V2500-A5/D5 SERIES PROPULSION SYSTEM NON-MODIFICATION SERVICE BULLETIN

This document transmits the Revision 2 of Non-Modification Service Bulletin V2500-ENG-72-0586.

V2500-ENG-72-0586

## NON-MODIFICATION SERVICE BULLETIN - ENGINE - HIGH PRESSURE (HP) COMPRESSOR BLADES - SAMPLING OF THE HP COMPRESSOR STAGE 5 ROTOR BLADE RETAINING PLATE SLOT

Figures 1, 2, 3 and 4

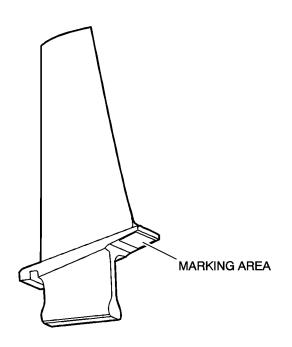
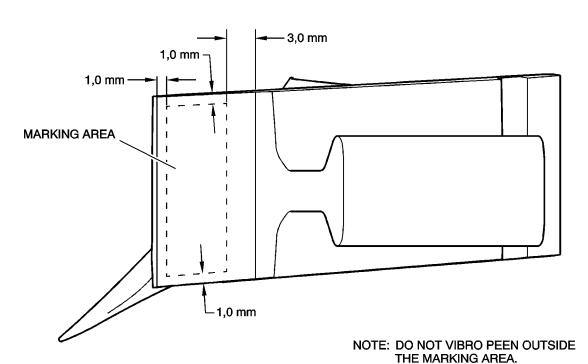
- (b) Examine the Stage 5 Rotor Blade retaining plate slots for cracks.
  - (c) Compare each blade to Figure 1 and Figure 2.
  - (d) Reject any HP compressor stage 5 rotor blade with a crack or an abrupt transition in accordance with Figure 1.

- (e) If any blade is found cracked in the retaining plate slot, reject the whole set of HPC stage 5 rotor blades.
  - (f) If rejected, quarantine the whole set of rejected HPC stage 5 blades and inform your local IAE office.

Area allocated for Part Marking (N 586) Figure 5

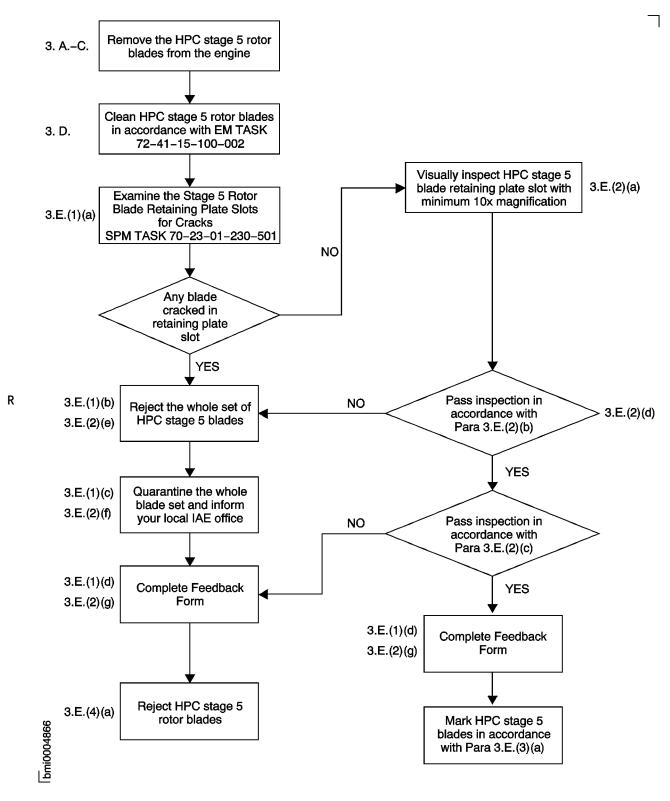
- (i) Vibro peen 'N 586' on each HPC stage 5 rotor blade that passed inspection in 3.E(1) in allocated area (Fig.5).
        - NOTE: Do not vibro peen outside the marking area.

- R NOTE: Any blade marked outside the marking area must be scrapped.
- R (4) HPC stage 5 rotor blades that failed inspection in 3.E(1) and 3.E(2)
- R (a) Reject all HPC stage 5 rotor blades that failed inspection in 3.E(1) and 3.E(2).
